Davis-Besse Nuclear Power Station, Unit No. 1
Docket No. 50-346, License Number NPF-3
Reply to Request for Additional Information for the Review of the Davis-Besse Nuclear Power Station, Unit No. 1, License Renewal Application (TAC No. ME4640), and License Renewal Application Amendment No. 9

Reply to Request for Additional Information for the Review of the
Davis-Besse Nuclear Power Station, Unit No. 1, License Renewal Application,
Sections 3.3, 3.5, 4.1, 4.3 and B.2.7

FIGURE 1 : AUXILIARY FEEDWATER NOZZLE GEOMETRY

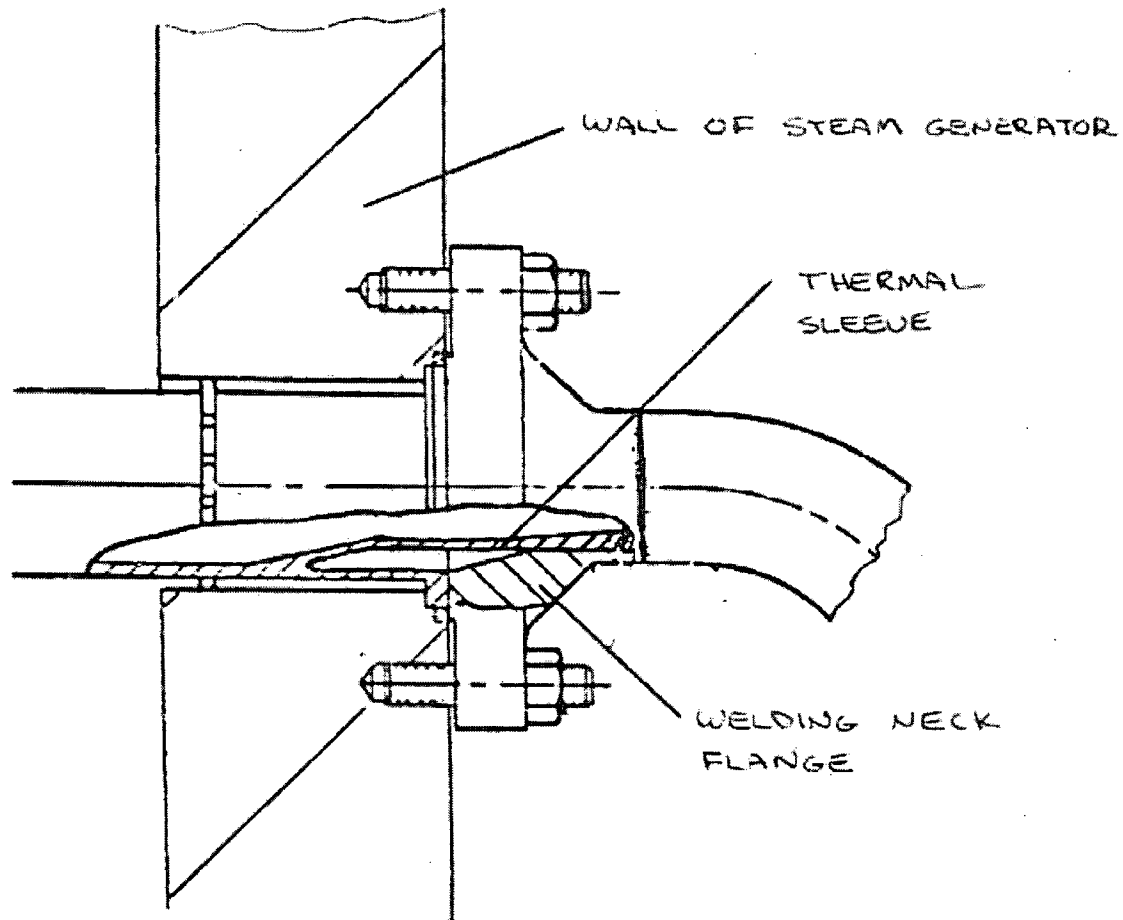
1. Clarify how the "auxiliary feedwater injection transient" for the modified AFW thermal sleeve design is related to the "Auxiliary Feedwater Bolted Nozzle 1-1," Transient 30A in LRA Table 4.3-1, and "Auxiliary Feedwater Bolted Nozzle 1-2," Transient 30B in LRA Table 4.3-1.
2. Clarify the cycle limit of 1447 for the "AFW initiations" transient discussed in the basis document for the metal fatigue TLAA and whether this "AFW initiation" transient is monitored by the Fatigue Monitoring Program during the period of extended operation. If not, justify why the "AFW initiations" transient does not need to be monitored by the Fatigue Monitoring Program during the period of extended operation.

The auxiliary feedwater injection transient used to evaluate the AFW nozzle thermal sleeves, AFW nozzle studs, and AFW nozzle flange (see Figure 1 of this response) assumes on/off control of the AFW system at a temperature of 40°F, flow duration per cycle of 425 seconds at 1000-1400 gallons per minute per steam generator, and 600 second interval from flow stop to flow start.

The AFW nozzle thermal sleeves were initially qualified for 300 AFW cycles in July 1982 using conservative analytical techniques (hand calculations). The thermal sleeves were reanalyzed in December 1982 using numerical methods and re-qualified for 40,000 AFW cycles. Thermal loads were as described above from AFW actuations with an initial bulk fluid temperature of 570°F. The fluid temperature changes from 570°F to 40°F instantaneously upon AFW actuation and returns to 570°F after AFW is stopped. Mechanical loads assumed in the evaluation of the thermal sleeves included transverse drag and oscillating lift from steam flow in the SG annulus, and hydrostatic pressure. NSSS design transients were not included in the thermal sleeve evaluation since it is not a pressure retaining item.

LRA change is required to shown that the AFW nozzle thermal sleeve is qualified for 40,000 cycles and that the AFW nozzle flange is qualified to 875 cycles of heatup/cooldown, boltup/unbolt and AFW initiation.

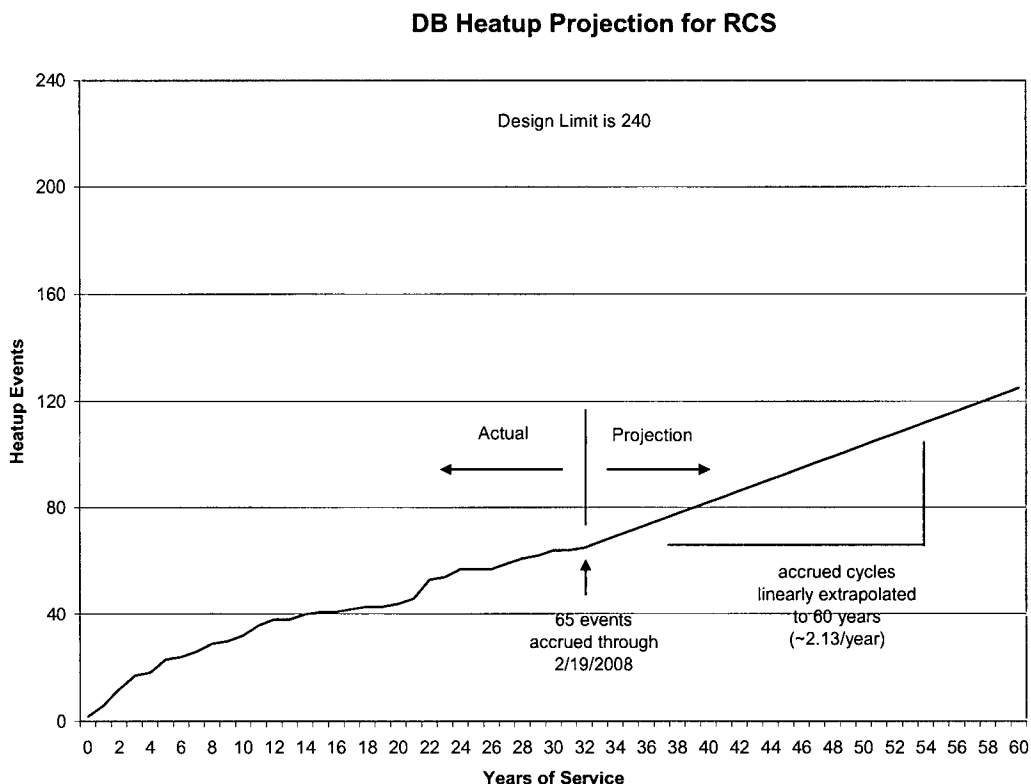
LRA Section 4.3.1.2 indicates that the number of cycles accrued as of February 2008 were compiled and linearly extrapolated to the 60 years of operation to determine whether the incurred cycles would remain below the number of design cycles.

The applicant did not justify the use of a linear extrapolation to determine the number of cycles for 60 years and whether it is conservative, based on its plant-specific operating history.

Explain the methodology used for the linear extrapolation of design transients and justify that the use of a linear extrapolation to determine the number of cycles for 60 years is valid and conservative, based on the plant-specific operating history.

Davis-Besse plant-specific operating history is similar to the operating history of other commercial nuclear power plants of similar vintage. Early in plant life, transients were frequent. As issues were resolved, the transient frequency decreased. In addition, the Davis-Besse fuel cycle has been increased to 2 years in duration resulting in a further decrease in transient cycles. Therefore, linear extrapolation of cycles that have occurred over the entire operating history of the plant to project 60-year cycles is conservative.

From plant startup (August 12, 1977) to February 19, 2008 the plant accrued 65 plant heatups. Using a linear extrapolation of these cycles, 65 cycles divided by 30.5 years, results in a rate of approximately 2.13 cycles/year. Using the assumption of 2.13 heatups per year for the remaining 29.5 years of operation, from February 19, 2008 through the period of extended operation, results in 128 heatups for 60 years of operation as shown in LRA Table 4.3-1.
